AGENDA FOR THE CANTERBURY BANKSTOWN LOCAL PLANNING PANEL MEETING

13 September 2021 - 6.00pm

ITEM 1	DA-1044/2020/1 - 10 Juno Parade, Bankstown
	Division 8.2 Review of Determination of Council's LPP's Refusal of DA-1044/2020 which sought approval for the demolition of existing structures and construction of a two-storey attached dual occupancy with Torrens title subdivision
FILE	DA-1044/2020/1 - Bankstown
ZONING	R2 Low Density Residential
DATE OF LODGEMENT	19 May 2021
APPLICANT	Pinnacle Plus
OWNERS	Rabah Marabay
ESTIMATED VALUE	\$739,837.67
AUTHOR	Planning

RE-1044/2020/1 ASSESSMENT REPORT

The proposed architectural roof features are identified and illustrated below:

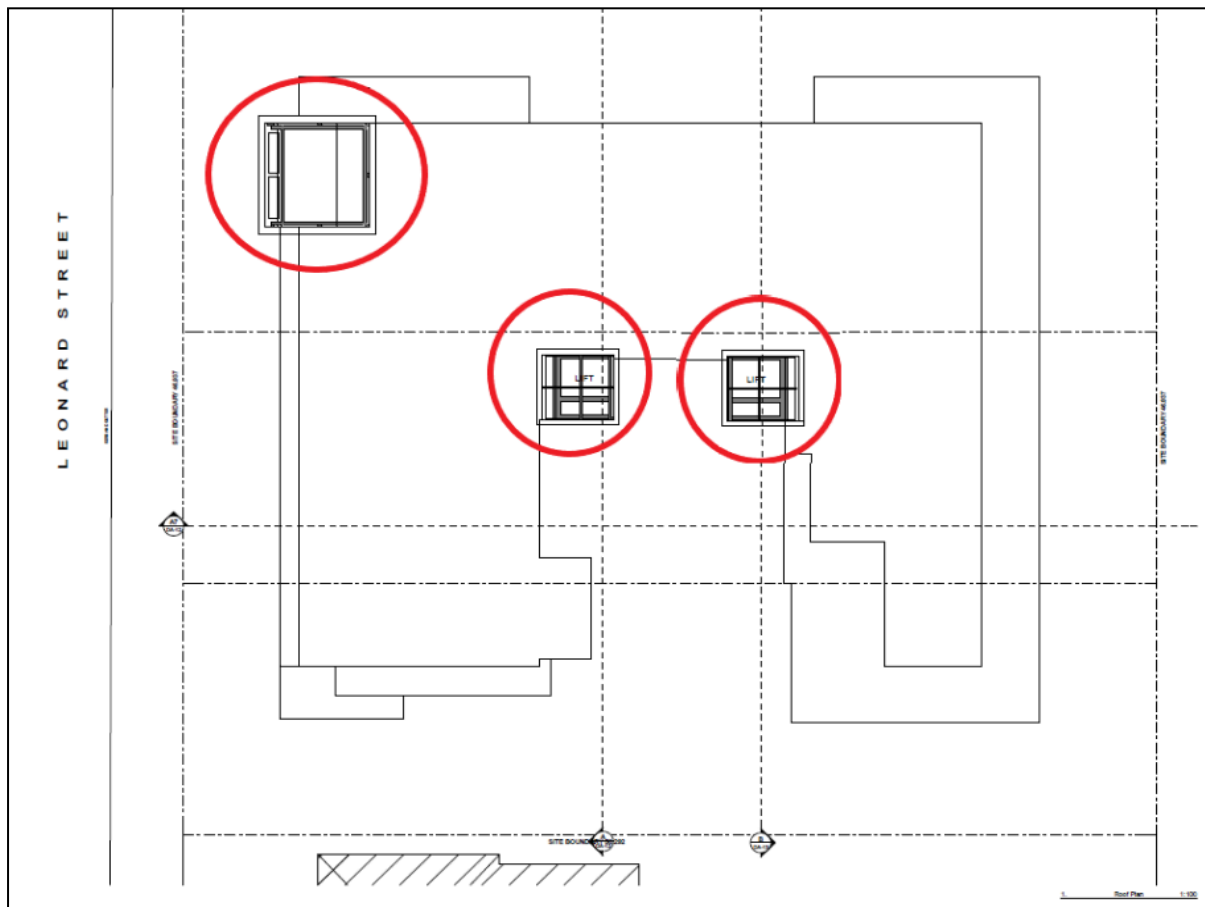
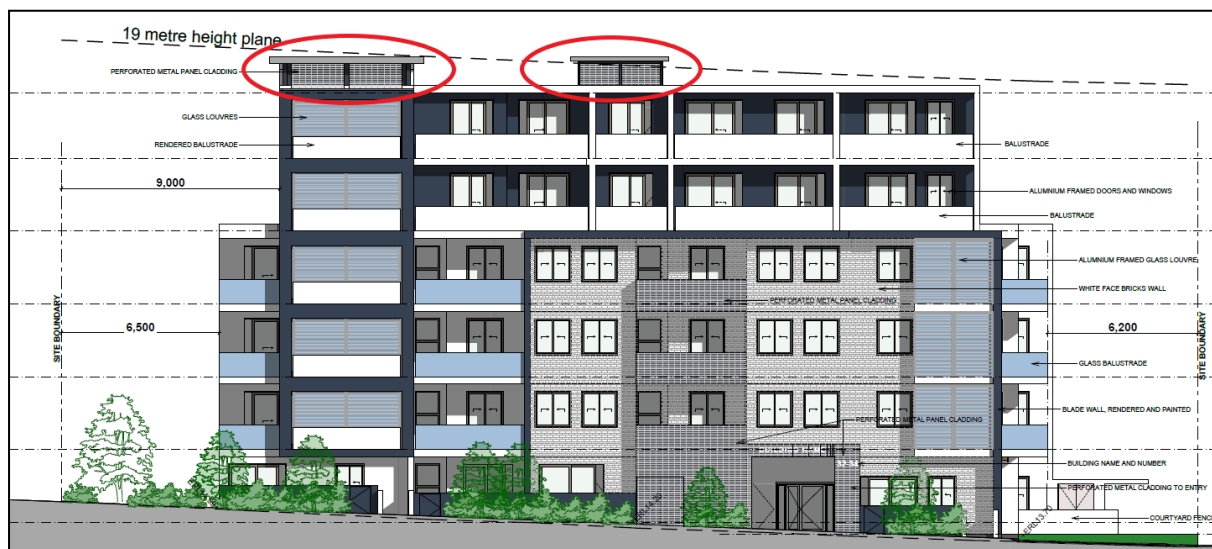
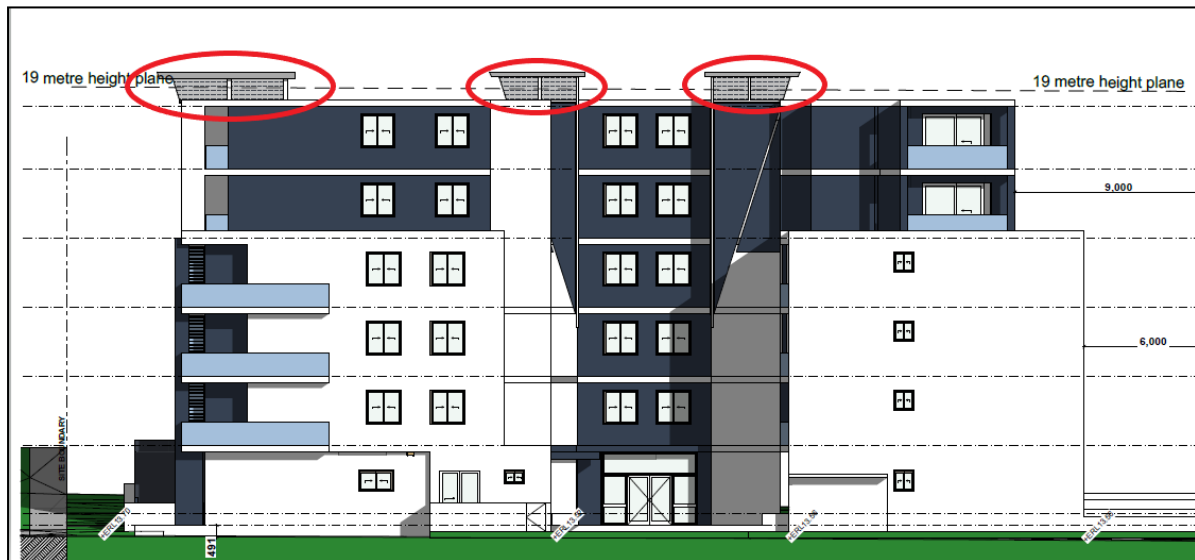
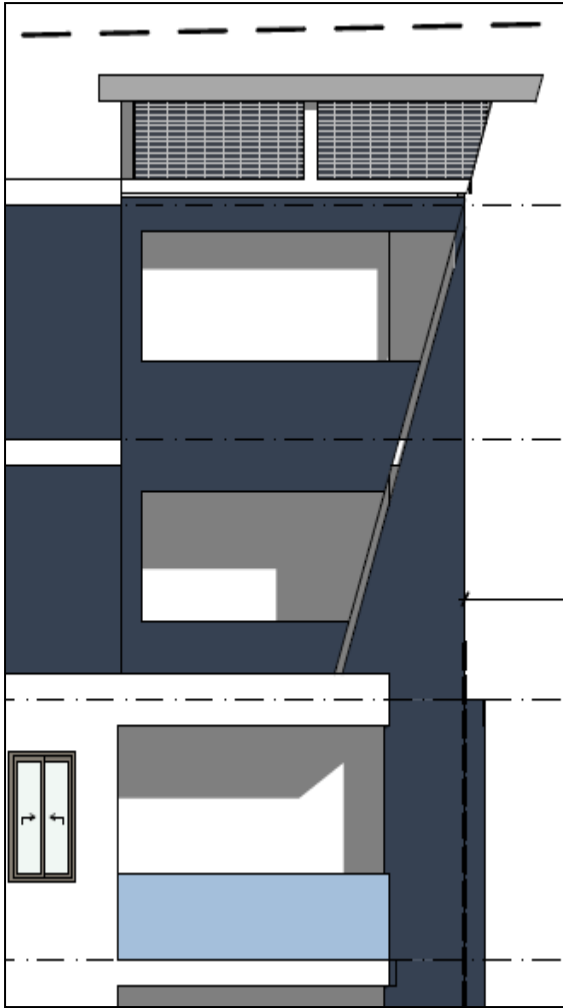
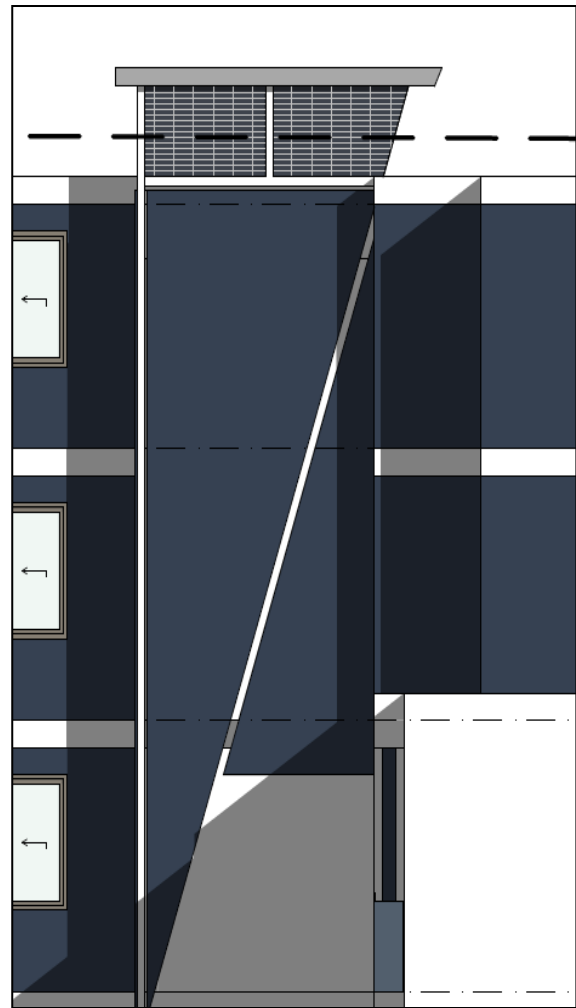
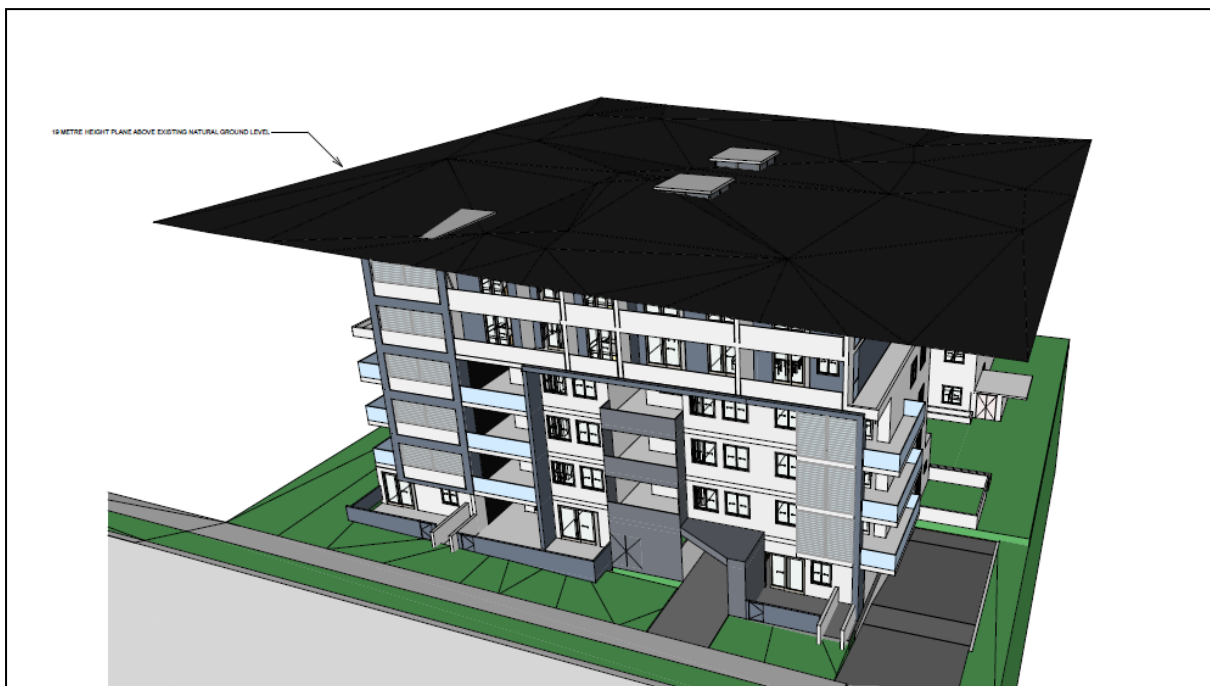
The above architectural roof features are decorative elements on the upper most portions of the building, which have been designed in a way that is integral to the buildings design. This is ensured by the location of the elements on the important portions of the building (highest points and corner element) and the use of the same perforated metal that defines the entryway to the building being replicated on the roof features.

It is not considered that the roof features are advertising structures, they do not include any floor space, nor are they reasonably capable of being modified to include floor space and they will cause only minimal overshadowing. As such, pursuant to Clause 5.6 of the BLEP 2015, it is considered that the proposed breaches to the height of building control are architectural roof features, and do not contravene Clause 4.3 of the BLEP 2015.

Figure 13: Landscape screen of substation

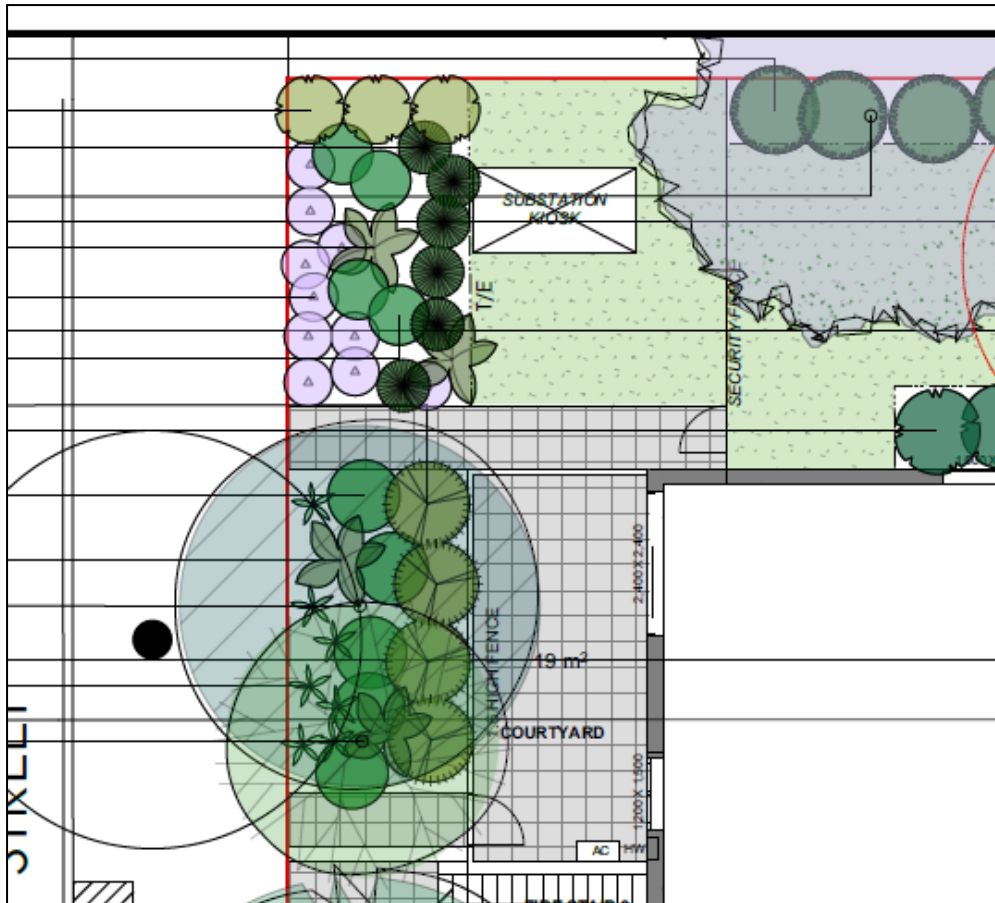
It is considered that the above plantings will provide sufficient visual screen such that the substation will not be visible from the street.
